The Banks – Phase 3C  
Public Infrastructure Development  
Bid Package #2 – Lot 28 Park & Garage  
January 21, 2022  
THP #98090.40

## **ADDENDUM #4**

5  
ELM ST. STAIR WALL  
**WALL SECTION**  
A202 1/4" = 1'-0"

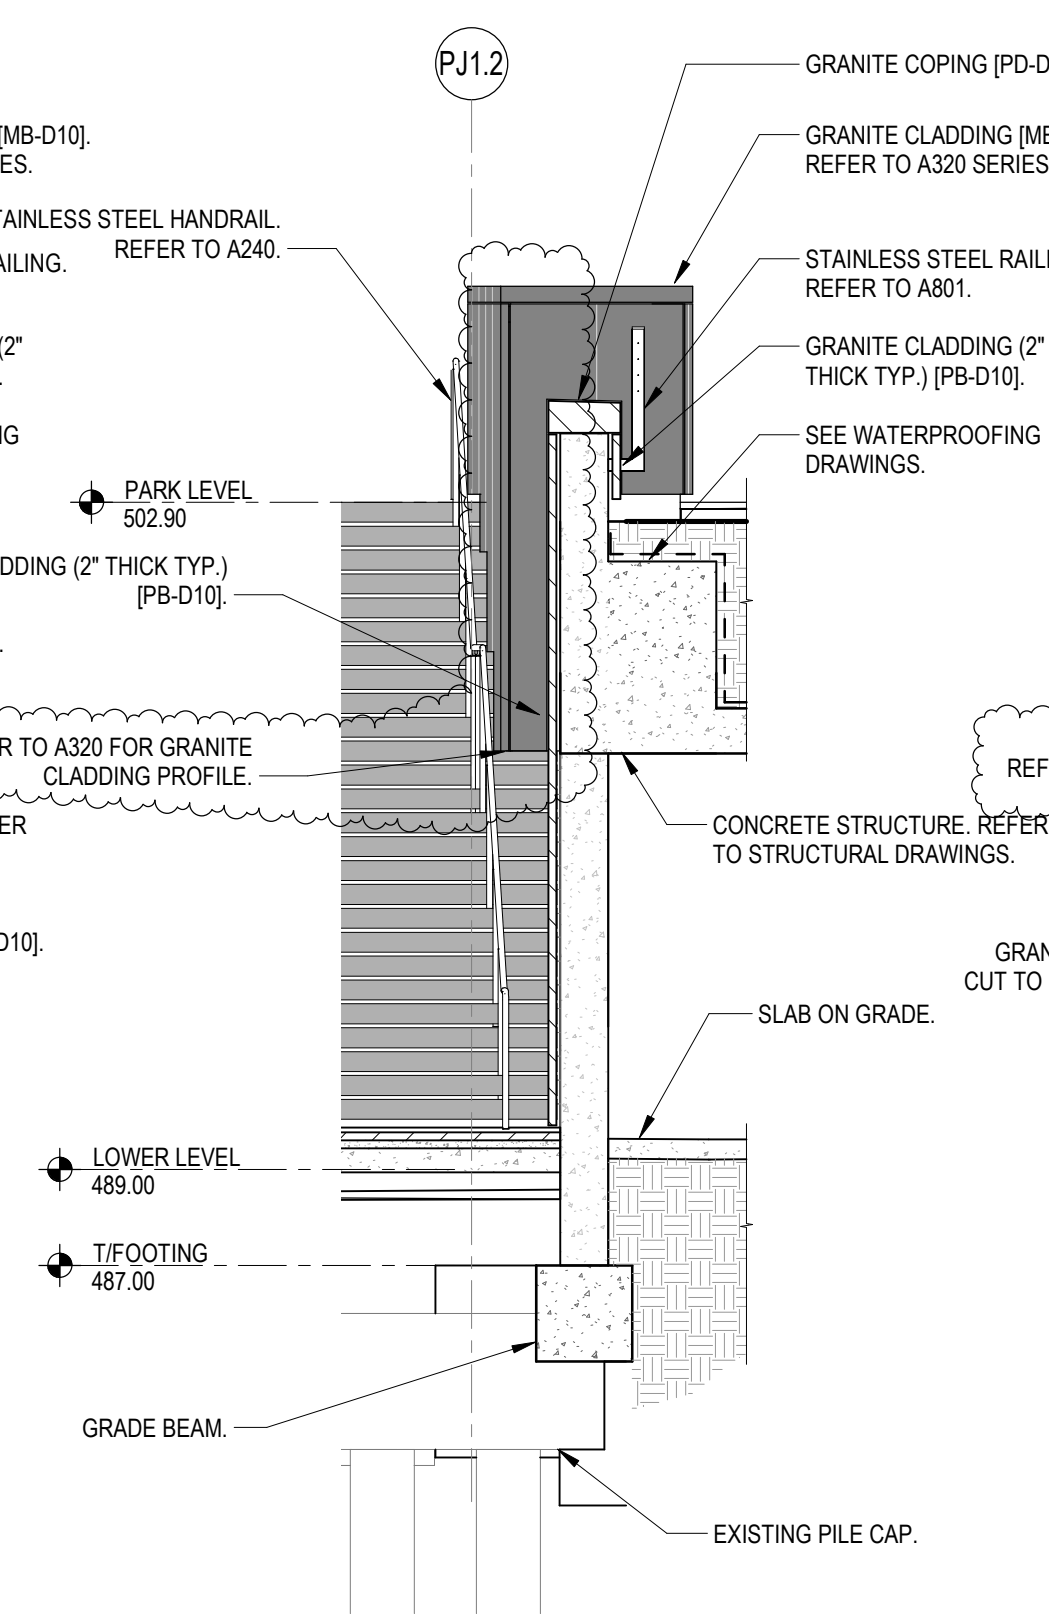
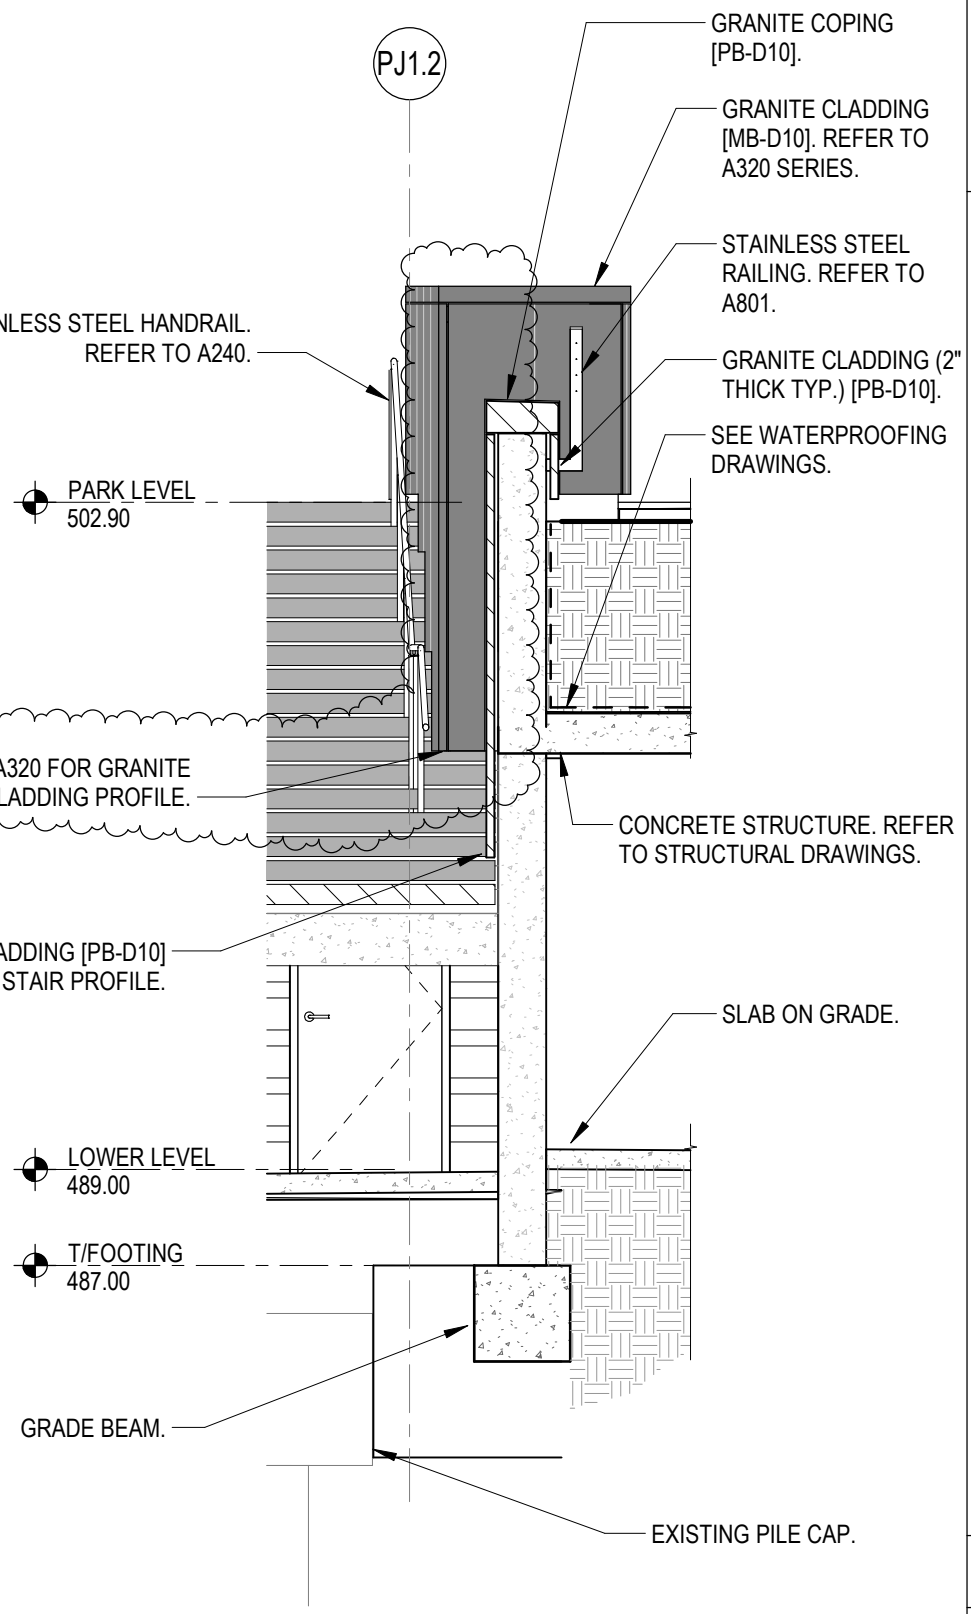
1. **Drawing A202:** (Sheet Reissued)
  - Extents of west granite cladding at the Elm St. Stair entry marker have been adjusted. See revision clouds.
2. **Drawing A240:** (Sheet Reissued)
  - Delete/disregard detail 3/A240 - refer to A801 for details on the back of concrete wall mounted rail.
  - Railing key plan, detail 5/A240, added for clarity.
  - The title of detail 4/A240 has been updated.
3. **Drawing A801:** (Clarification)
  - Delete/disregard Details 3 & 4/A801 – there are no longer any glass railings in BP #2.
4. **Drawing S201:** (Sheet Reissued)
  - Revise Section 11/S201 to accommodate seating bench along Mehring Way sidewalk.
